# DEVELOPMENT PLAN—PARCEL 3

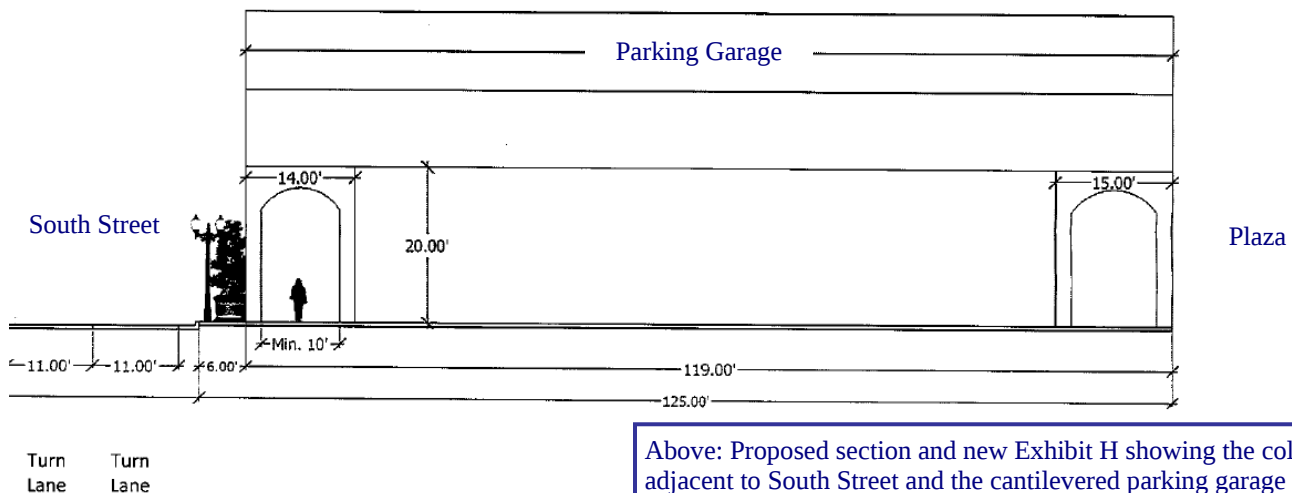
Below: Parcel 3 proposed diagram of encroachment into South Street ROW for Colonnade. A SPMP is still required for Parcel 3, however, South Street was realigned adding an additional lane, which affected the ROW for Parcel 3. In order to fit a feasible parking garage on the site and still meet the existing conditions of the PD, a study was conducted of the possible streetscape as a colonnade and a parking podium encroaching over the ROW as shown.
